ADDENDUM NO. 3
TENDER NO. 40-20
RIVERSIDE PARK (CENTENNIAL POOL) WASHROOMS RENOVATION

March 9, 2020

This addendum amends and forms part of the Tender Documents. The bidder shall insert the addendum behind the cover page of the Tender Documents.

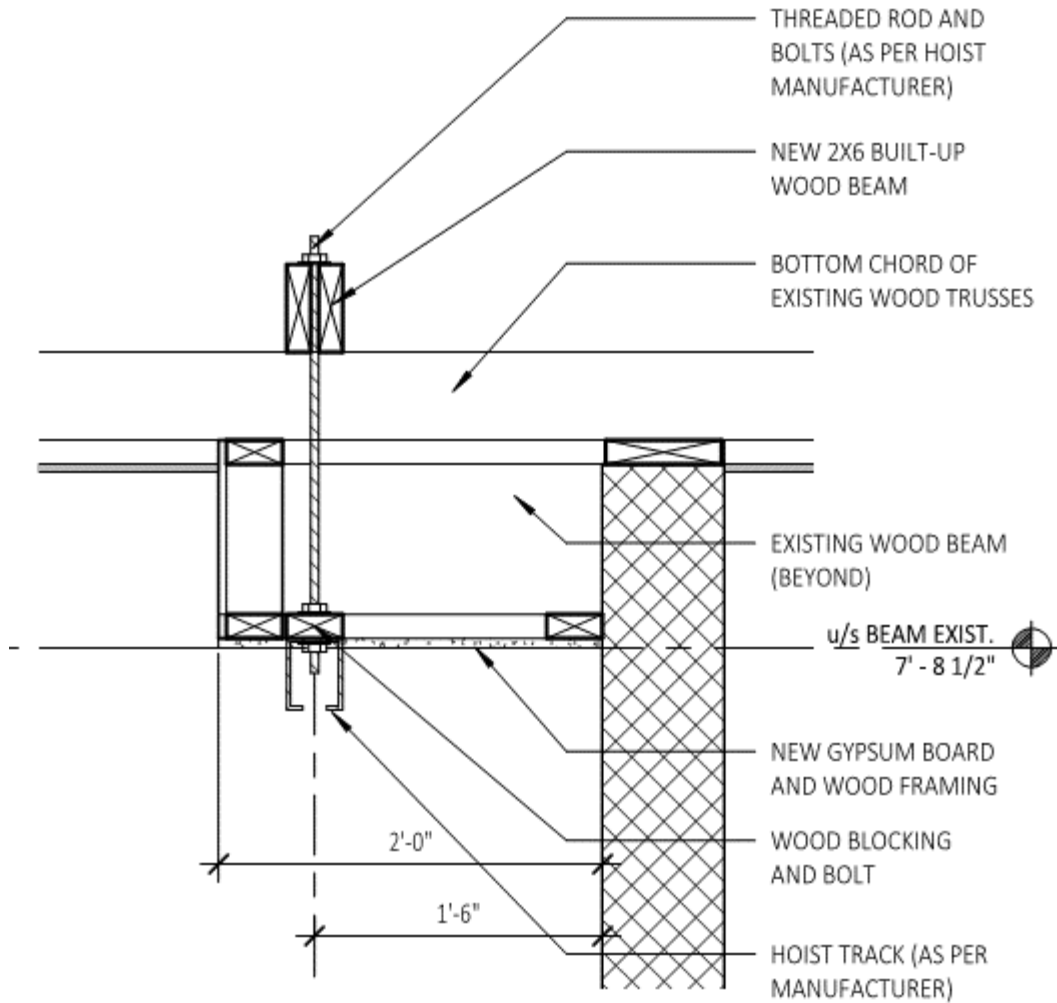
.2 Add: Item No. 21 in the Accessories and Equipment List to read “ Height-Adjustable Power Change Table”. Item to be located in BF/WR 104 only.

.3 Supply and install one (1) electrically height adjustable nursing bench, Max-Ability Pressalit Care 1000, model #R8401 (or similar), 1800mm (70.86”) length, with 400mm (15.75”) adjustment height, white, with PVC coated canvas bench and coated steel frame, 150 kg (330 lb) max. load, complete with wired hand control module and wall holder. Unit shall be capable of being folded up out of the way when not in use. Includes handrail.

.4 Clarification: Supplier to include warranty, inspection/maintenance schedule and local service contact information. Supplier to provide visual instructions to illustrate to users how to operate lift.

4 SECTION DETAIL AT HOIST

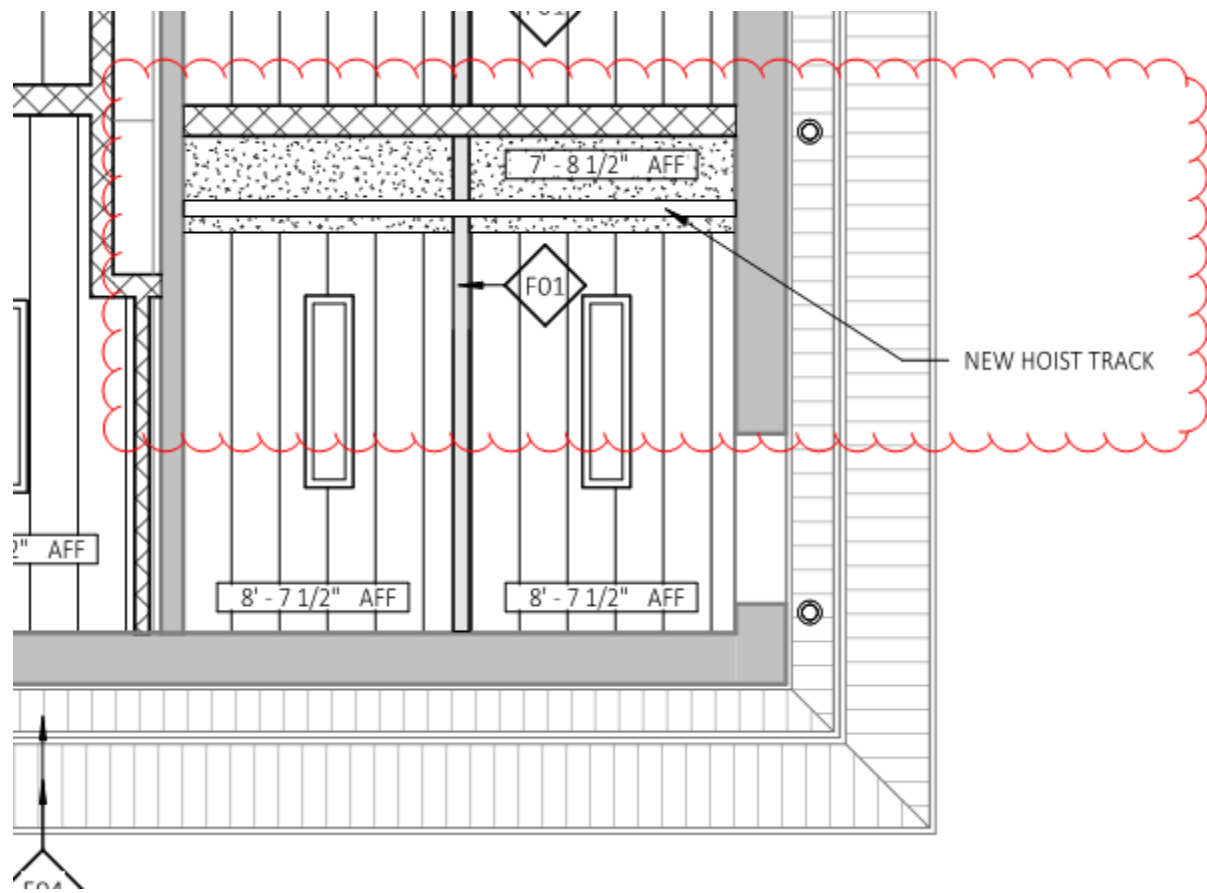
.2 Refer to Sketches SK-202-01, SK-202-02 and SK-301-01 (Issued)

- .1 Add: built-up wood beam on top of bottom chord of existing roof trusses, to extend the full length of BF/WR 104 (east to west).
- .2 Add: gypsum board bulk head as shown on plan and detail.
- .3 Clarification: There are to be a minimum of 2 threaded rod connections on either side of the existing wood beam.

HOIST TRACK TO BE CENTRED WITH WATER CLOSET
